Project	IEEE 802.16 Broadband Wireless Access Working Group < http://iee802.org/16 >	
Title	Comments on IEEE 802.16e Handoff Draft	
Date Submitted	2003-03-11	
Source(s)	Changhoi Koo Jungje Son Sohyeon Kim Panyuh Joo Samsung Elec. IT center 21 st fl. Maetan 3 dong, Paldalgu Suwon, Kyungido Korea	Voice: +82-31-279-5091 Fax: +82-31-279-5130 chkoo@samsung.com Junje.son@samsung.com binde.kim@samsung.com panyuh@samsung.com
Re:	Call for inputs for the Handoff Ad-hoc group	
Abstract	This documents is to make a set of comments and modifications on Handoff AdHoc document.	
Purpose	Some of comments would be adopted into Draft Handoff proposal generated by HO AdHoc group.	
Notice	This document has been prepared to assist IEEE 802.16. It is offered as a basis for discussion and is not binding on the contributing individual(s) or organization(s). The material in this document is subject to change in form and content after further study. The contributor(s) reserve(s) the right to add, amend or withdraw material contained herein.

HO mechanism for IEEE 802.16e

Figure ZZZ. Basic cell concept

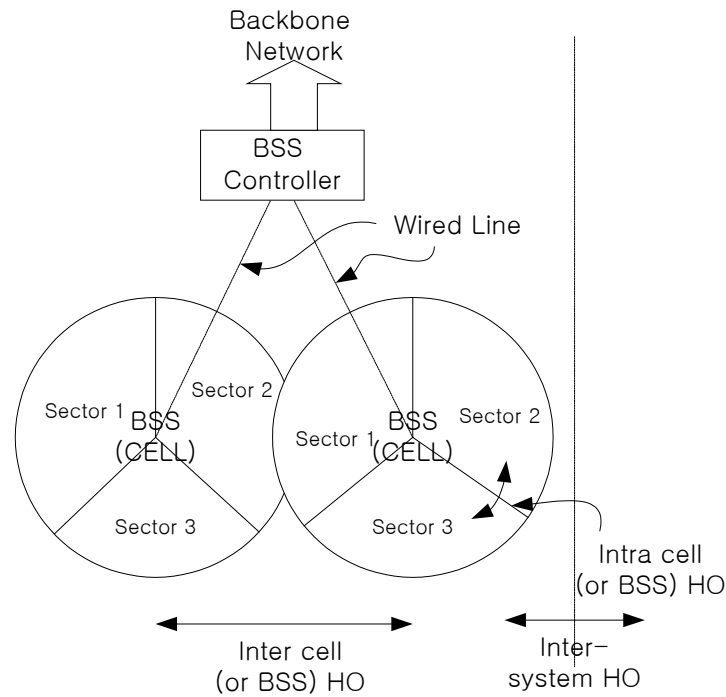
(CHKOO : What does mean “ a single central controller”? I understand one central controller is connected with a set of BSS and control the BSS during HO. Am I right? If I am correct, how to communicate between BSS and BSS. Do they communicate through a central controller?)

(CHKOO : What does mean “cell”? I understand that one BSS is a cell which consists of multiple sectors. Am I right? If I am correct, the definition of BSS surely shall be changed. To make firm inter-cell and intra-cell HO, I figure out the diagram as followings.)

(CHKOO : We need to define the role and figure of Central Controller, and the IB interface between BSS and BSS through Controller.)

Figure 7: HO and initial network entry Figure 8: MSS procedures with HO triggering operation

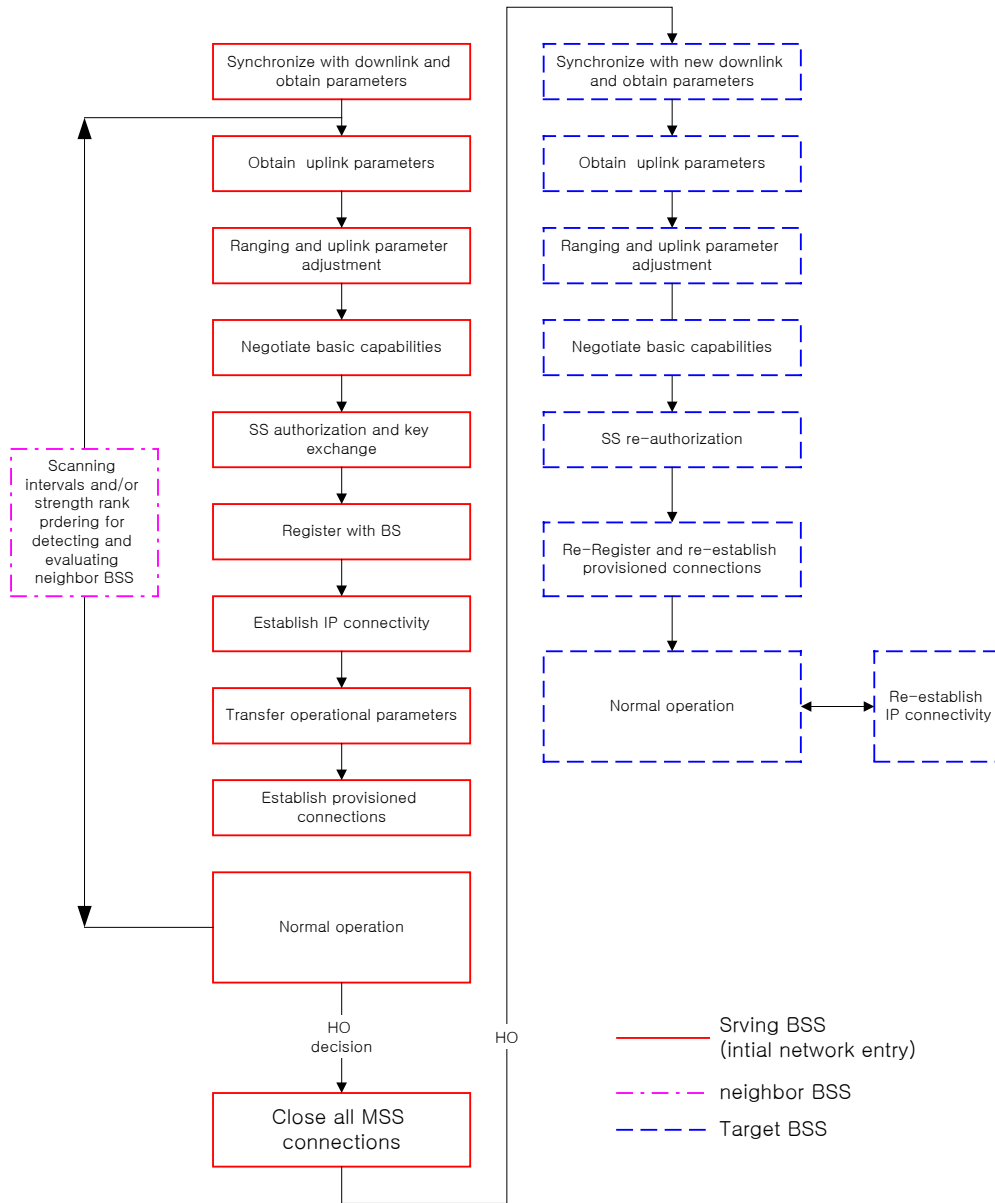
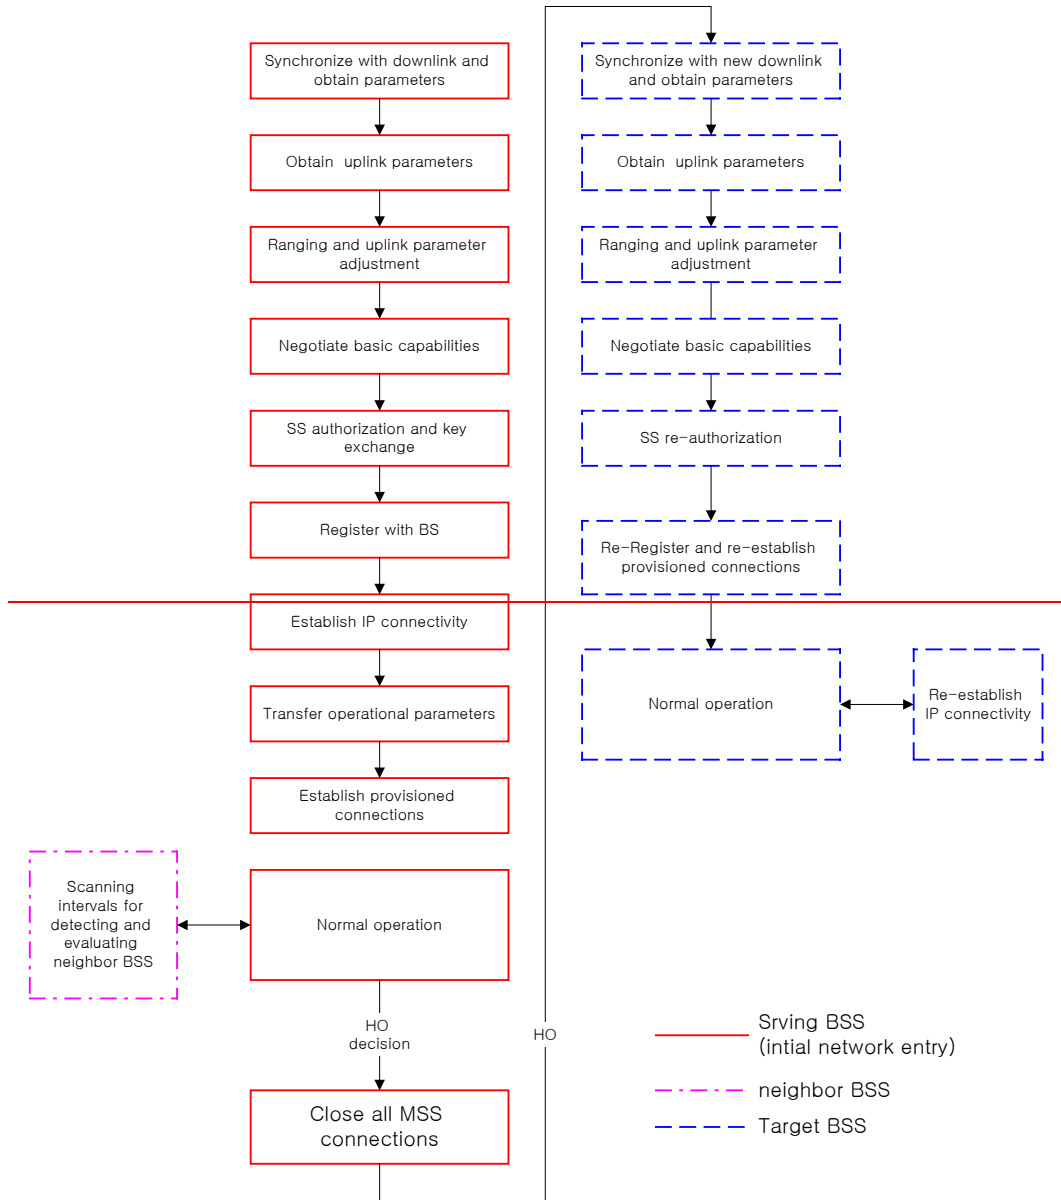
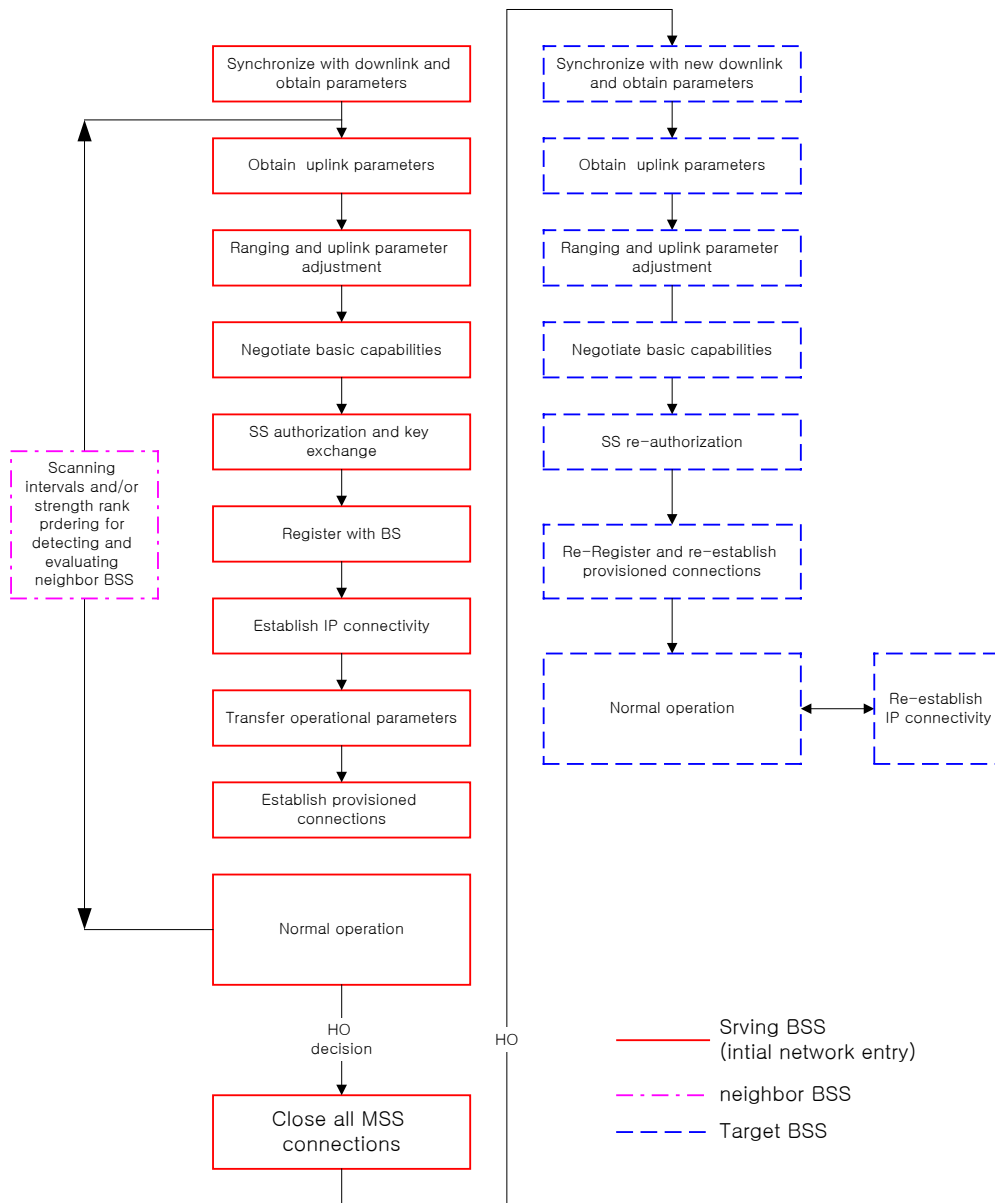
(CHKOO : The HO process is performed during transmitting the user packet data(In-traffic HO on the dedicated channel) and non-transmitting the user packet data(Idle HO on the common channel). Furthermore, those procedures are really different and should be defined separately. In my understanding, the overall HO including points of the Idle and In-traffic HO is depicted in figure 7)

Figure 10: View of a HO process in the time domain

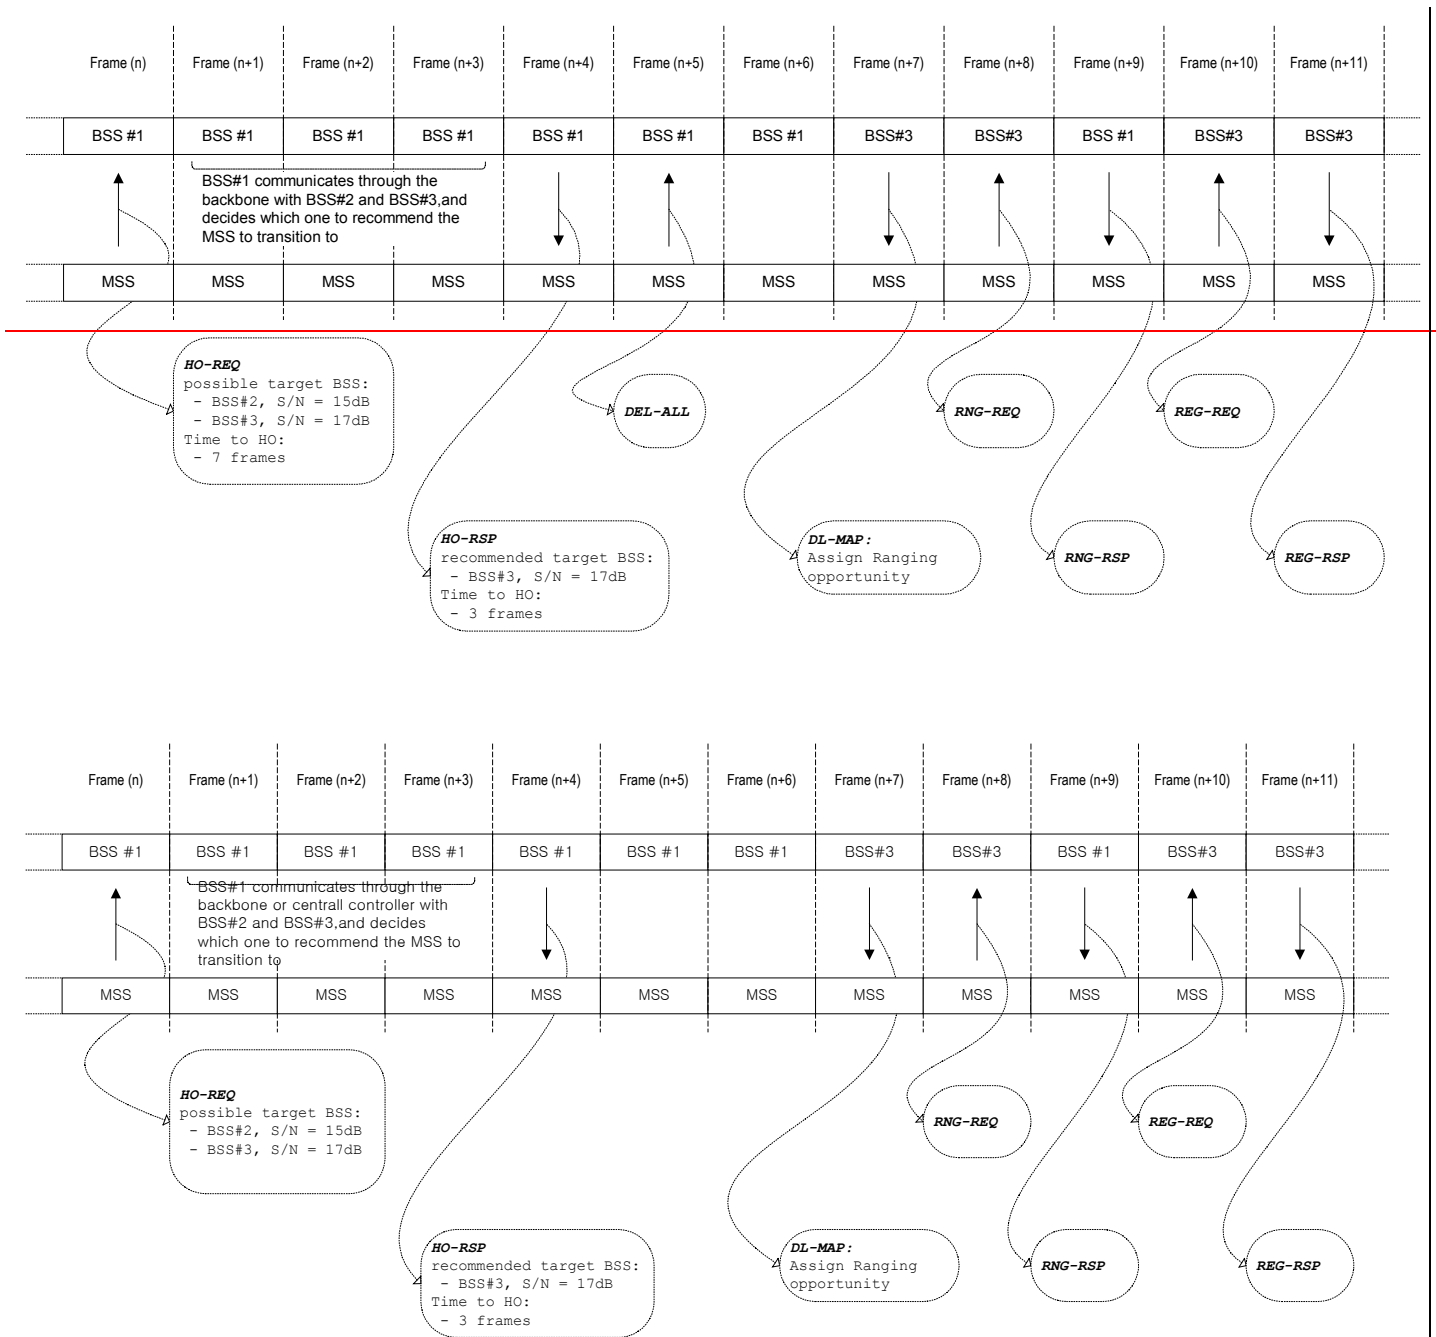
(CHKOO : Estimation time is not required but activation time(time to HO in figure 10) which indicates the actual HO operation to receive the data from the target BSS)
